To: All Bidders for Downers Grove Grade SD 58 Playground Improvements for Four Schools project

SUBJECT: **ADDENDUM #1 TO THE BID DOCUMENTS FOR:**
Playground Improvements for Four Schools

Project No: 210223

10 CLEANOUT
 SCALE: 1" = 1'-0"

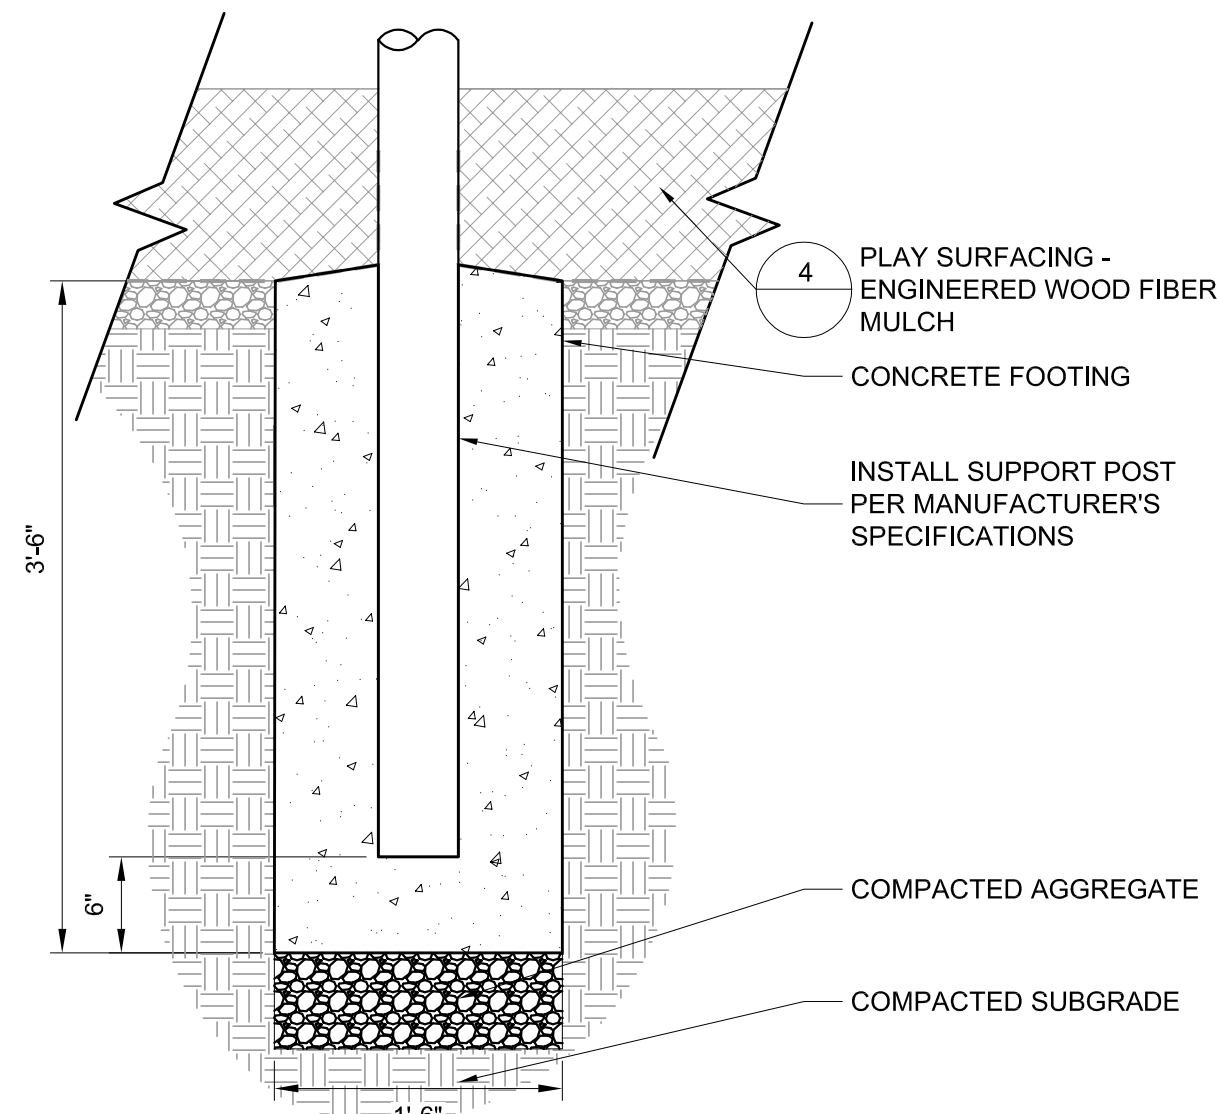
- 1. C0.01 General Notes
 - a. Note 22 has been revised.
- C3.00
 - a. Grading and drainage have been revised.
- C3.01
 - a. Utilities has been updated.
 - b. Asbuilt notes have been revised.
- C4.01
 - a. Detail 10 has been revised.
- C4.02
 - a. Sheet has been added.

11 CLEANOUT
 SCALE: 1"=1'-0"

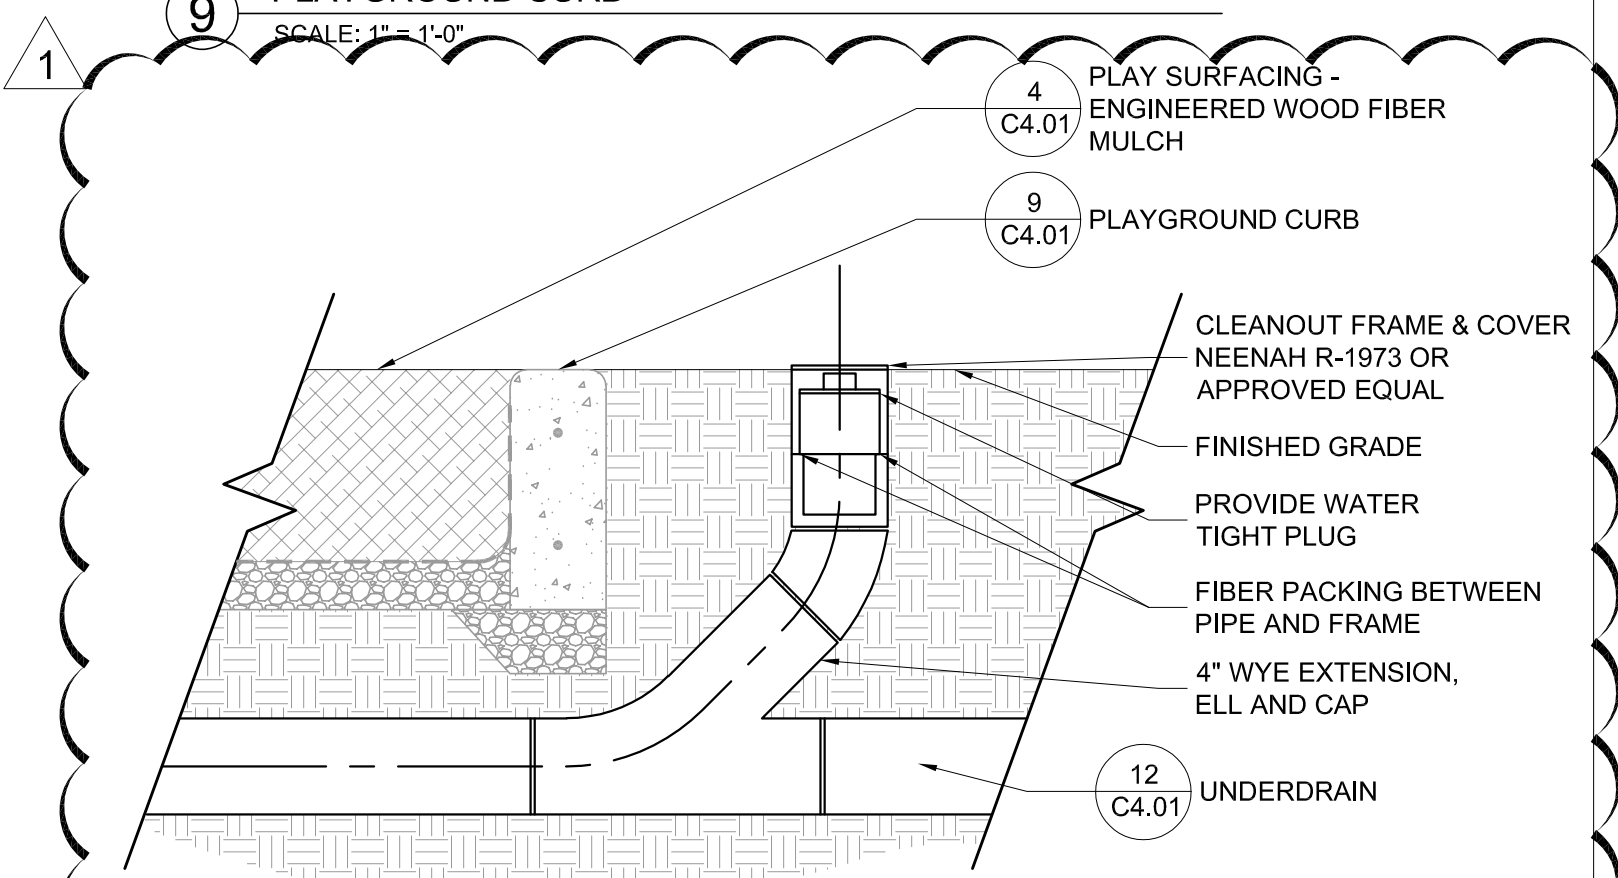
- a. Note 10 has been removed.
- C3.01
- a. Grading and drainage have been revised.
 - b. Asbuilt notes have been revised.
- C4.01
- a. Detail 11 has been revised.
- C4.02
- a. Sheet has been added.

13 CLEANOUT
 SCALE: 1"=1'-0"

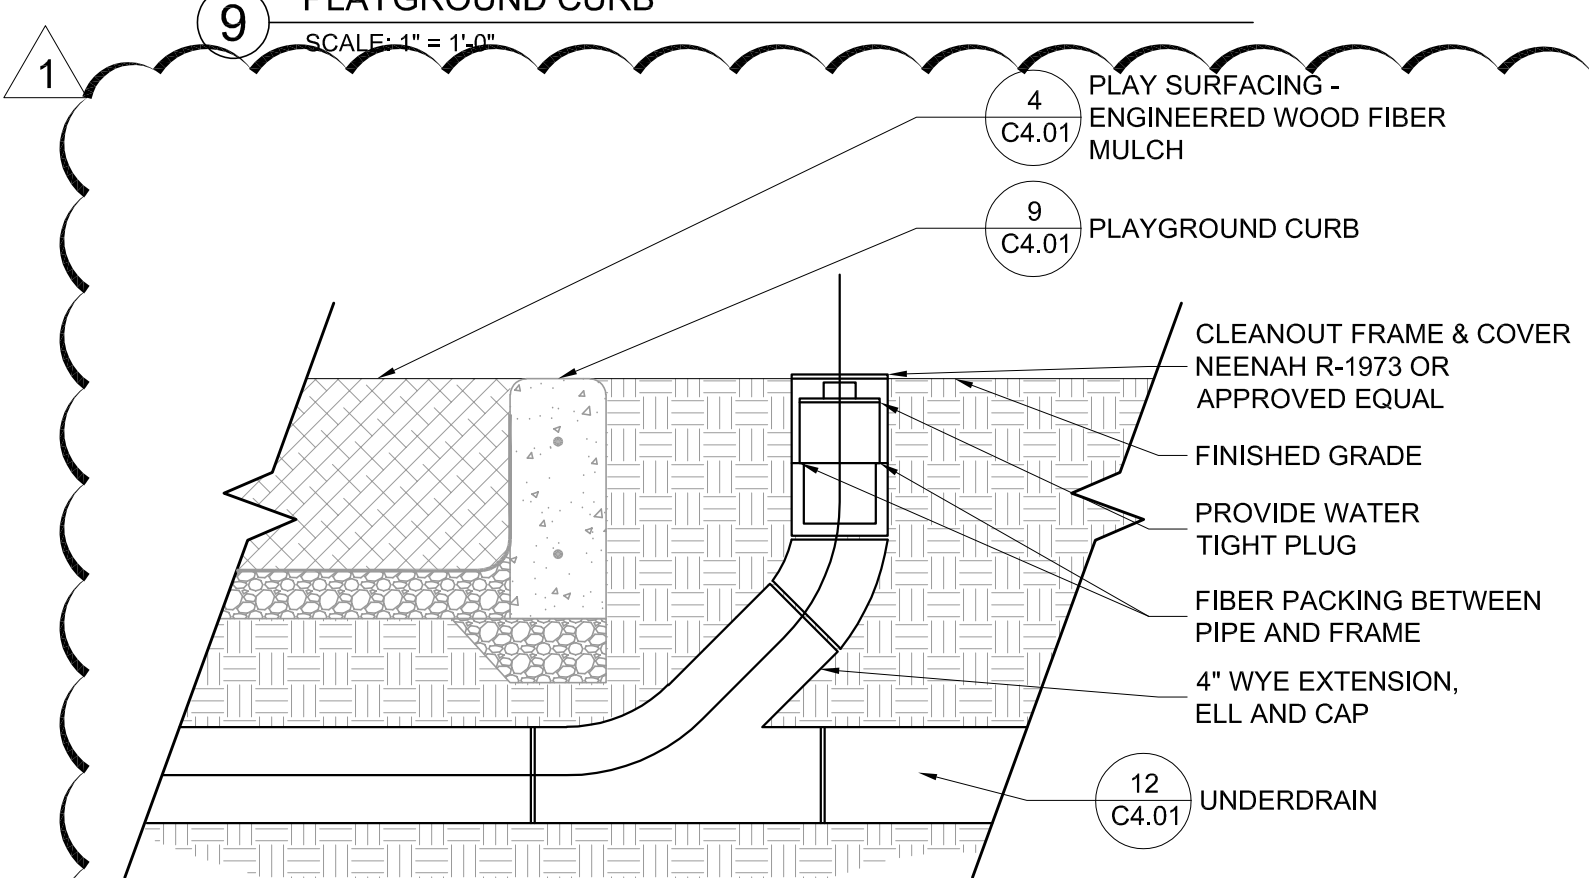
- 1. C0.01 General Notes
 - a. Note 22 has been revised.
- C1.00
- a. Keynote 3 has been revised.
- C2.00
- a. Note 10 has been revised.
- C3.00
- a. Asbuilt notes have been revised.
- C4.01
- a. Detail 7 has been removed.
 - b. Detail 13 has been revised.
